This addendum incorporates additional Wi-Fi and conduits to address the infrastructure for the RGB lighting system.

# Pre-Bid ADDENDUM 2
## (DSA ADDUNDUM 1)

# Murrieta Mesa High School

# MVUSD ATHLETIC LIGHTING UPGRADE

**E1.2**

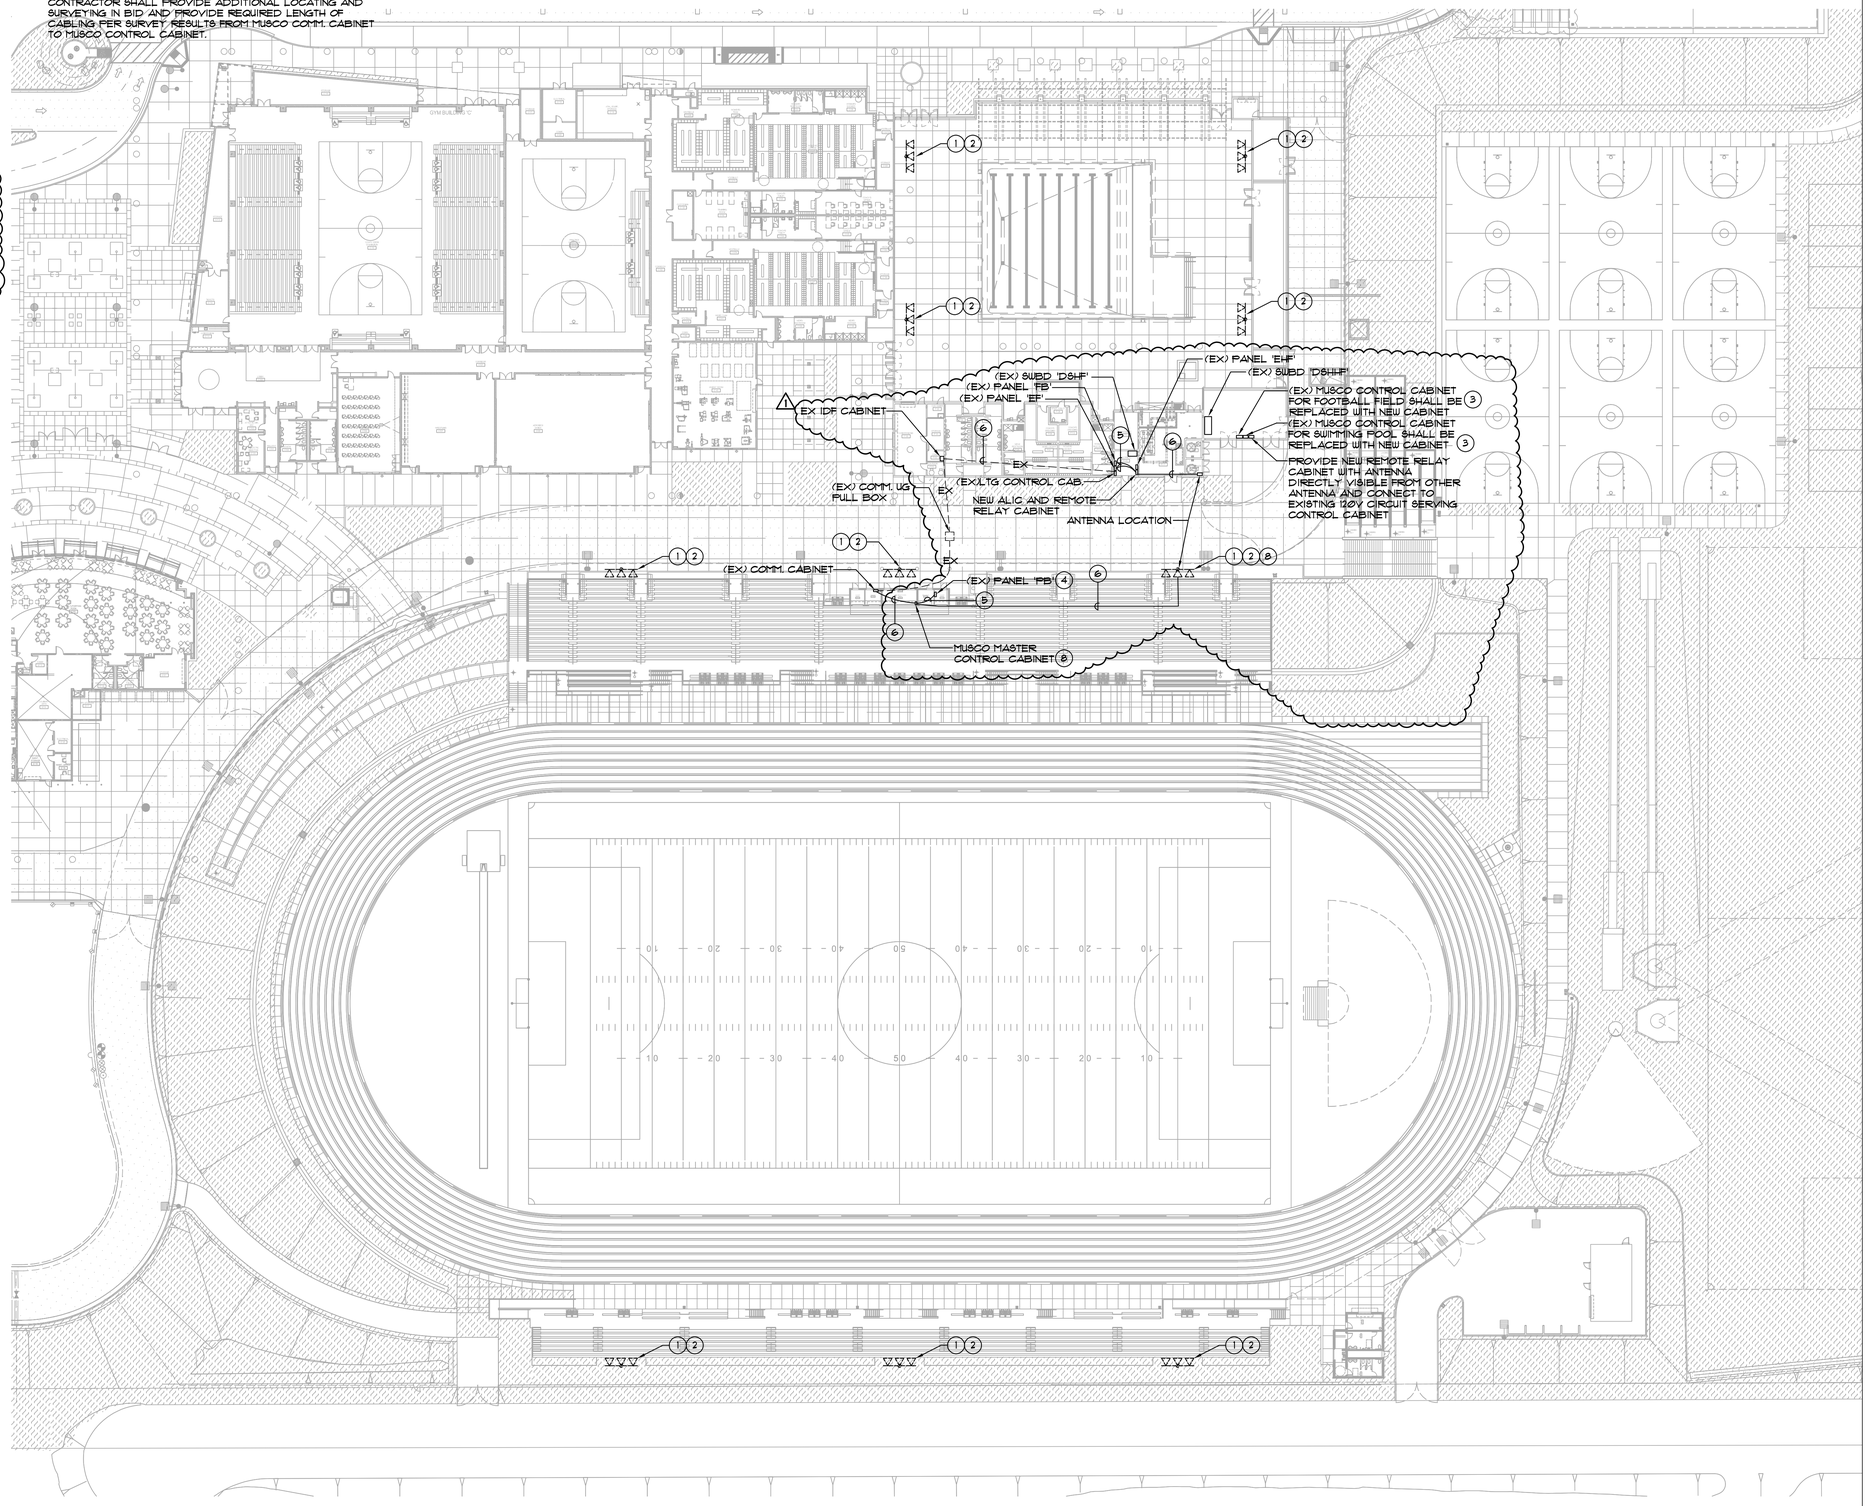
**A.** Drawing E1.2 – ENLARGED SITE PLAN: Revised currently issued drawing per AD-E1.2

7. PROVIDE NEW 1"C. FROM REMOTE RELAY CABINET TO ANTENNA LOCATION. VERIFY EXACT LOCATIONS WITH MANUFACTURER.
8. PROVIDE NEW MASTER CONTROL CABINET WITH 1"C. FROM CONTROL CABINET TO POLE LOCATION. MOUNT ANTENNA ON POLE SO IT HAS DIRECT LINE OF SITE TO THE OTHER ANTENNAS

**E7.1**

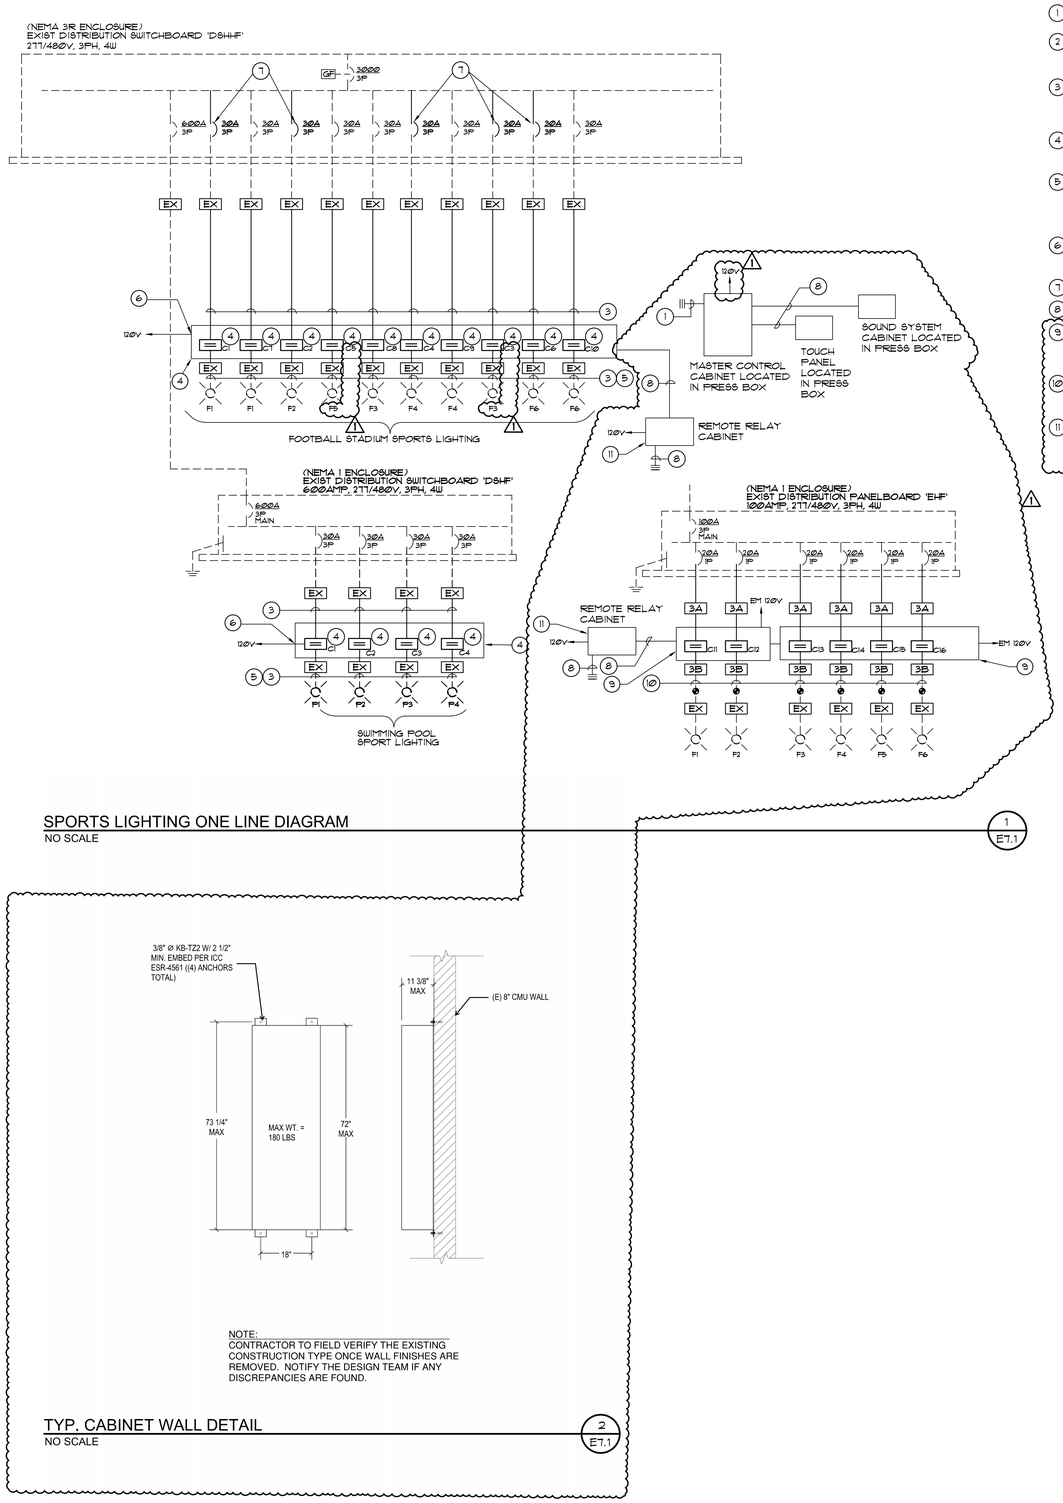
**B.** Drawing E7.1 – SPORT LIGHTING ONE LINE DIAGRAM: Revised currently issued drawing per AD-E7.1

10. INTERCEPT EXISTING CONDUCTORS AND ROUTE NEW CONDUCTORS FROM ALIC THROUGH THE EXISTING CONDUITS OUT OF PANEL EHF.
11. PROVIDE REMOTE RELAY CABINET AND 1"C. FROM CABINET TO ANTENNA LOCATION. VERIFY EXACT LOCATION WITH MUSCO AS REQUIRED. ANTENNAS MUST BE IN DIRECT LINE OF SIGHT OF EACH OTHER.
